8 SUB2015-00127

CEFCO SCHILLINGER THREE NOTCH SUBDIVISION

DETAIL SITE PLAN

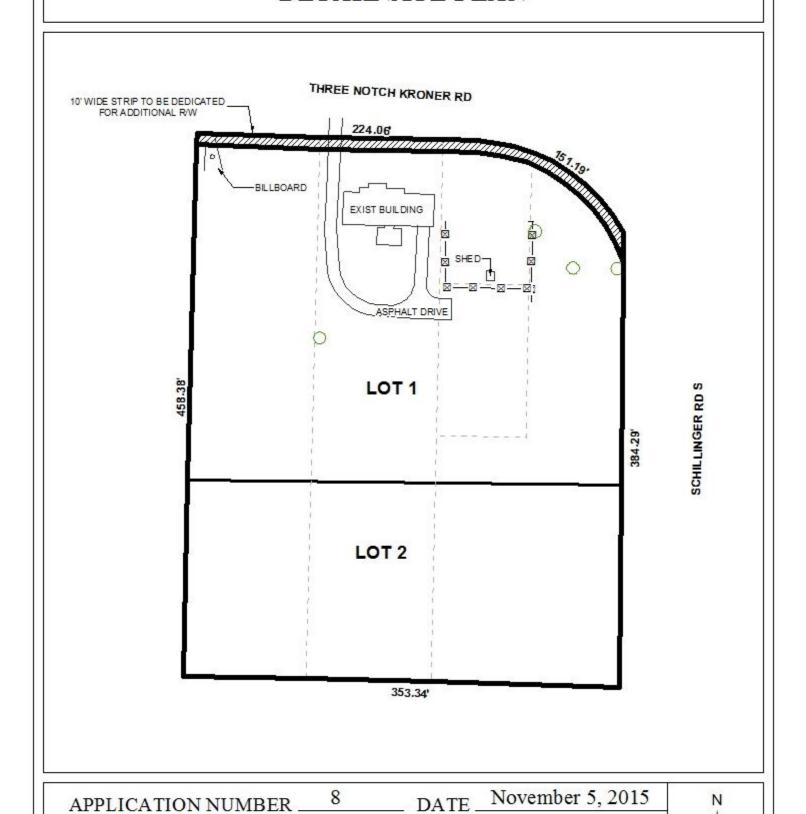
The site has frontage on Three Notch Kroner Road to the North, a major street requiring a 100' right-of-way, and Schillinger Road South to the East, a major street also requiring a 100' right-of-way. Right-of-way widths are not depicted on the preliminary plat for either of the roads; thus the plat should be revised to depict and label the minimum existing right-of-way width and, if necessary, dedication to provide 50' from the centerline of Three Notch Kroner Road and Schillinger Road, if approved. It should be noted that previous dedication of the right-of-way along the Three Notch Kroner Road frontage of Lot 1 is shown on the plat.

Dedication of the corner radii at Three Notch Kroner Road and Schillinger Road South should be required per Section V.D.6. of the Subdivision Regulations.

As a means of access management, a note should be required on the Final Plat stating that Lot 1 is limited to one curb cut to each street, and that Lot 2 is limited to one curb cut to Schillinger Road South, with its size, location and design to be approved by Mobile County Engineering, and conform to AASHTO standards.

The preliminary plat does not indicate a 25' building setback line for either of the two proposed lots as required by Section V.D.9. of the Subdivision Regulations. If approved, the minimum building setback line should be illustrated on the Final Plat along all frontages.

Each lot meets the minimum size requirements of the Subdivision Regulations and is labeled in acres, but not square feet. If approved, each lot size should be labeled with its respective size in

square feet and acres on the Final Plat, adjusted for any required dedication, or a table should be furnished on the Final Plat providing the same information.

This site is located in the County, thus any lots which are developed commercially and adjoin residentially developed property must provide a buffer, in compliance with Section V.A.8. of the Subdivision Regulations. A note regarding this requirement should appear on the Final Plat, if approved.

- 1) labeling of the minimum existing right-of-way width for each street and, if necessary, dedication to provide 50' from the centerline of both Three Notch Kroner Road and Schillinger Road South;

- 2) dedication of the corner radii at Three Notch Kroner Road and Schillinger Road South, per Section V.D.6. of the Subdivision Regulations
- 3) placement of a note on the Final Plat stating that Lot 1 is limited to one curb cut to each street, and that Lot 2 is limited to one curb cut to Schillinger Road South, with its size, location and design to be approved by Mobile County Engineering and conform to AASHTO standards:

- 4) illustration of the building setback line along all frontages on the Final Plat;
- 5) placement of a note stating the lot sizes in square feet and acres on the Final Plat, or the furnishing of a table on the Final Plat providing the same information, adjusted for dedication:

- 6) placement of a note on the Final Plat stating that any lots which are developed commercially and adjoin residentially developed property must provide a buffer, in compliance with Section V.A.8. of the Subdivision Regulations;
